PLANNING AND ZONING COMMISSION OF JEFFERSON COUNTY, MISSOURI
NOTICE OF MEETING

A. PR123035

A Request for a Zone Change and Development Plan Application for parcel 08-5.0-21.0-0-000-001., located northwest of Old Highway M and Old Lemay Ferry Road, in Imperial Township and Council District #7, from Non-Planned Community Commercial (CC-2) Zone District and Planned Industrial (PI) Zone District to Planned Single-Family Residential (PR-1) Zone District and Development Plan approval for Antonia Estates.

ANTONIA ESTATES SUBDIVISION DEVELOPMENT PLAN

Jefferson County Planning and Zoning Commission
729 Maple Street
Hillsboro, MO 63050
Subject: PP23038

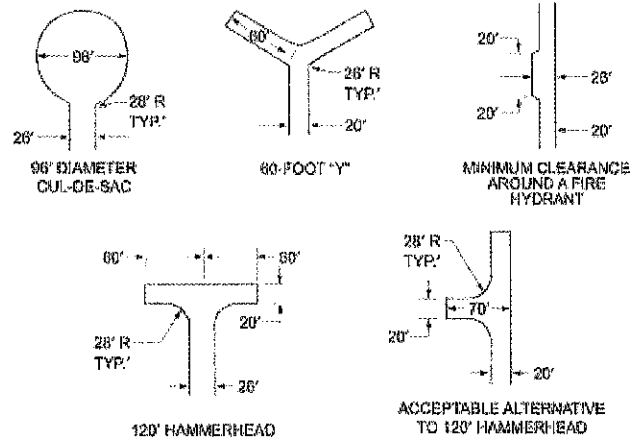
I am writing to express our concerns regarding the planned residential development, particularly focusing on the dimensions of the proposed cul-de-sac.

The dimensions of the proposed cul-de-sac in the development plan raise significant concerns for our emergency response capabilities. A properly designed cul-de-sac is essential to accommodate the turning and maneuvering of emergency vehicles, particularly fire trucks and ambulances. Based on our experience and best practices, we recommend the following minimum dimensions for the cul-de-sac:

We urge the commission to work closely with the developer to revise the cul-de-sac design to meet these safety standards.
